BID #722 – Moorpark College – ANCT ZOO VISITOR BLEACHERS AND ANIMAL SHELTER

ADDENDUM 001, dated 01/29/2026

DRAWING changes and clarifications noted as Addendum 01 and dated 01/29/2026:

G. Ticketing Office

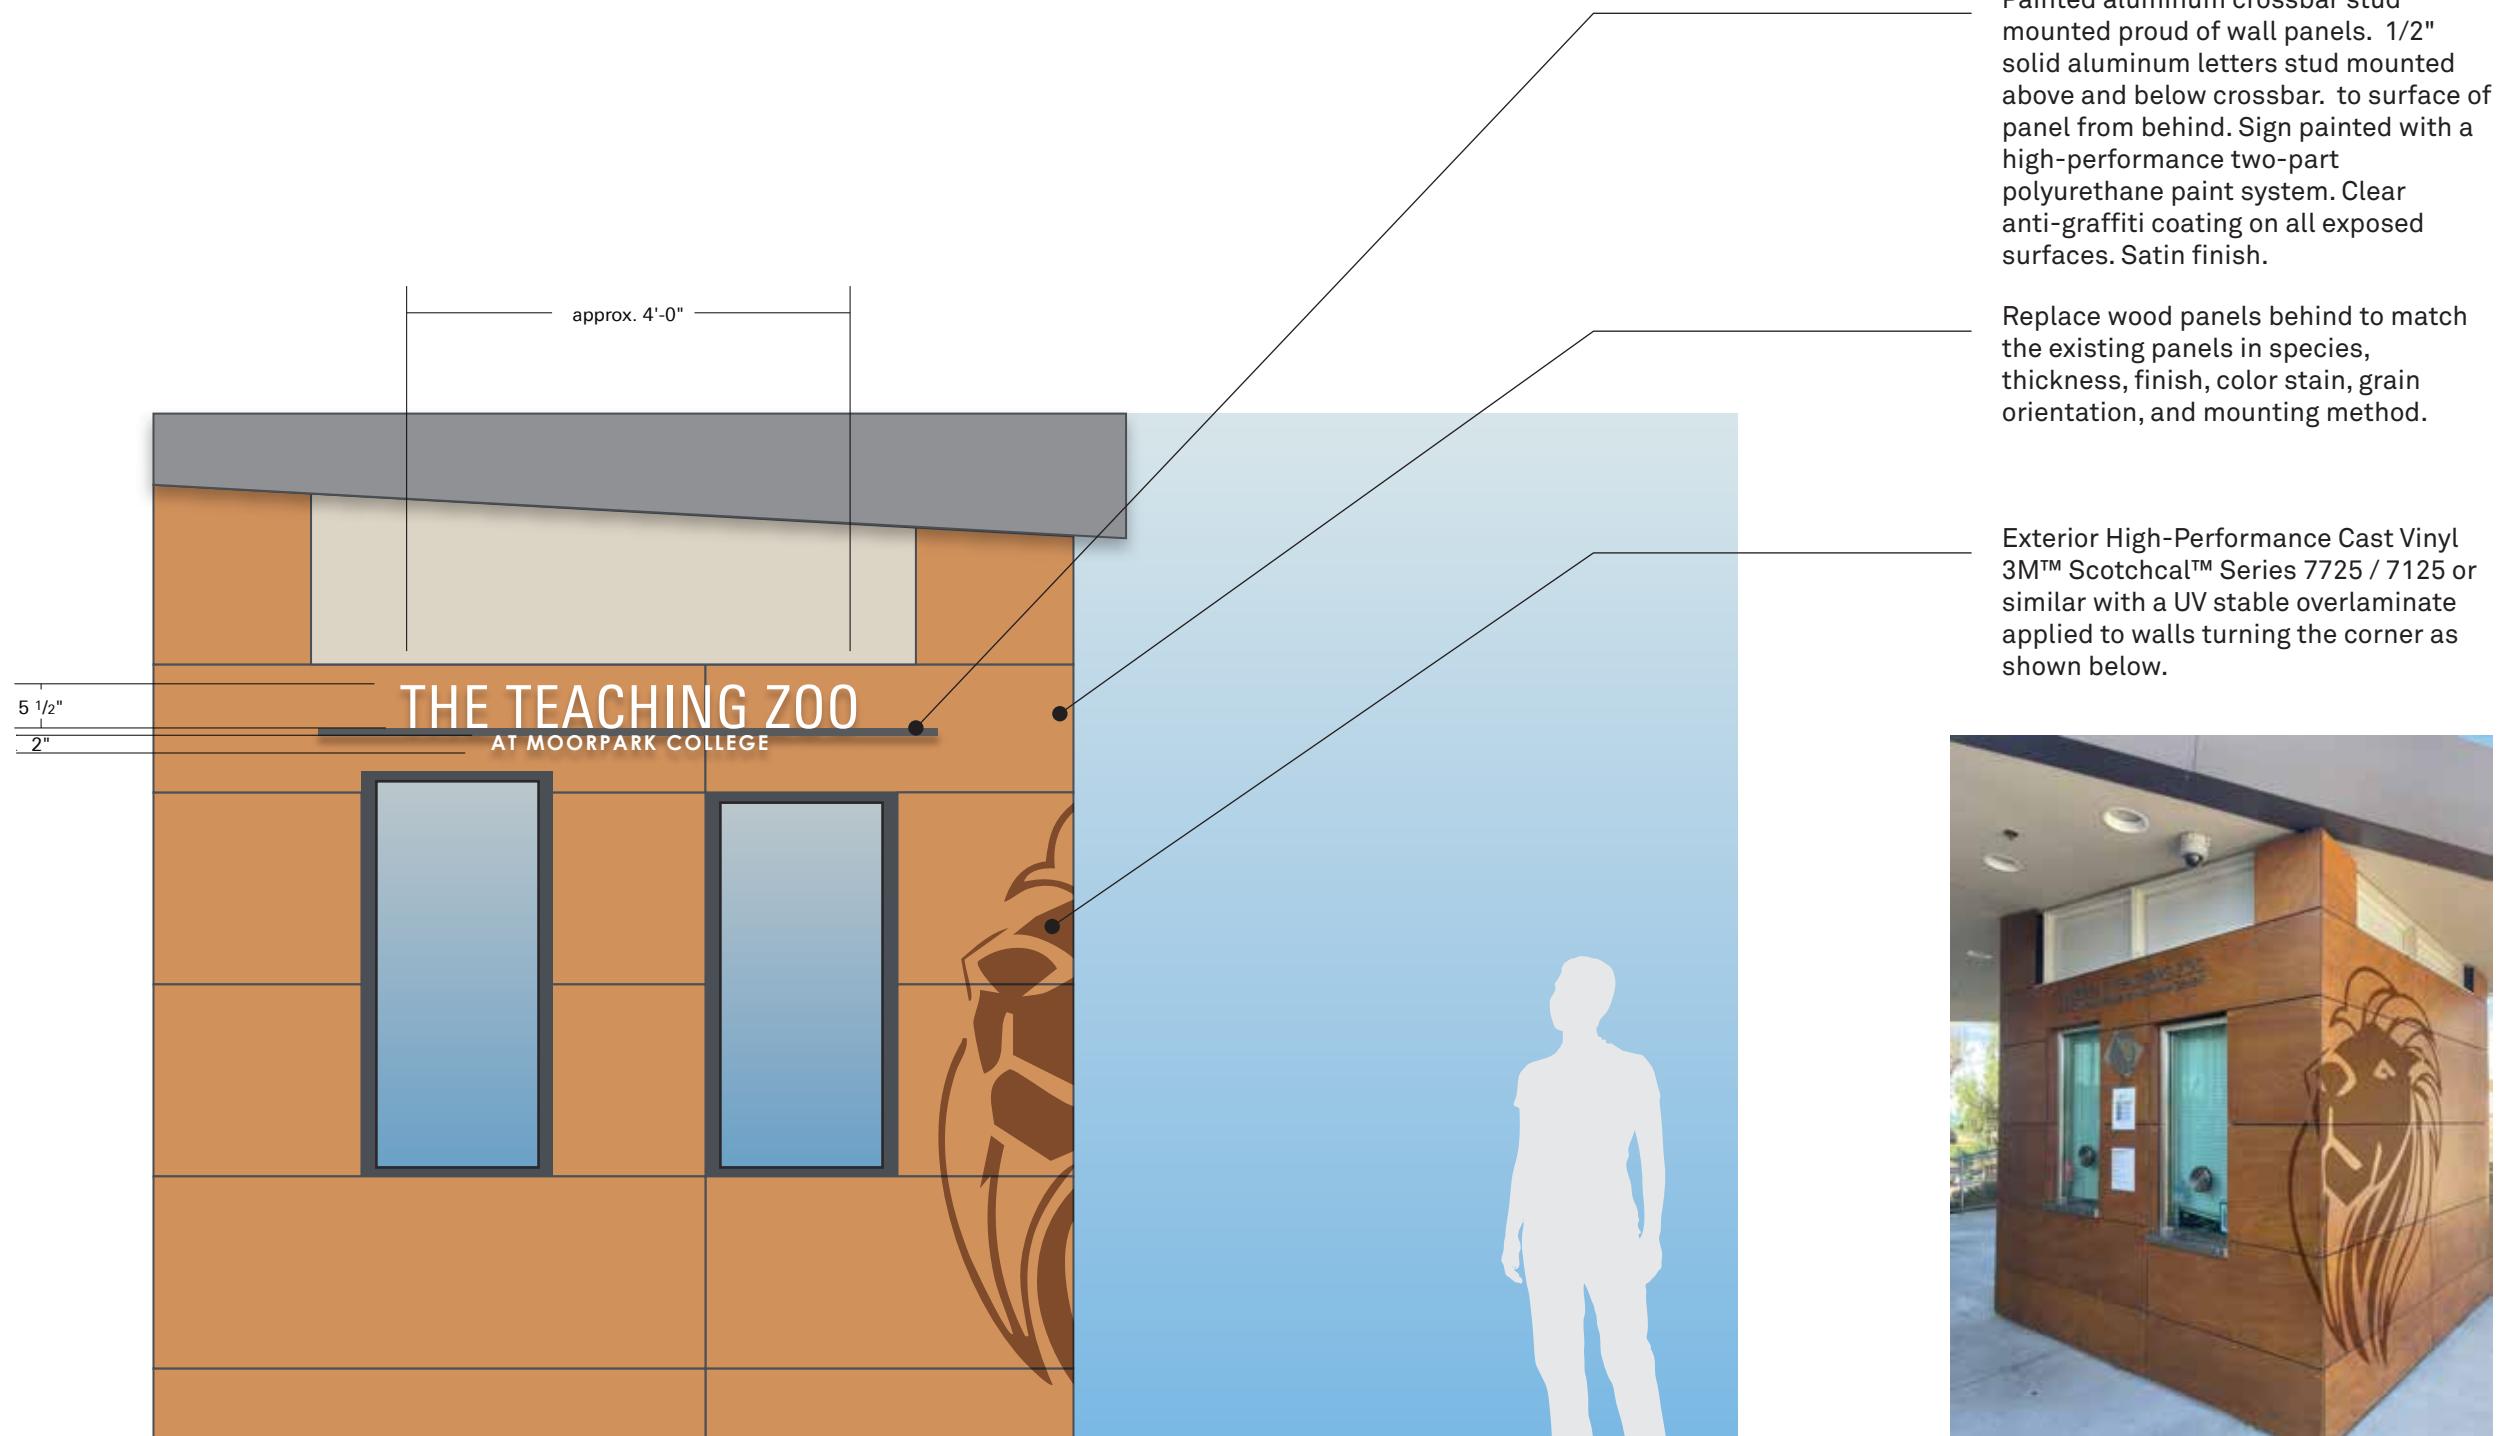
Replace existing letters over existing panels with dimensional letters on a rail.
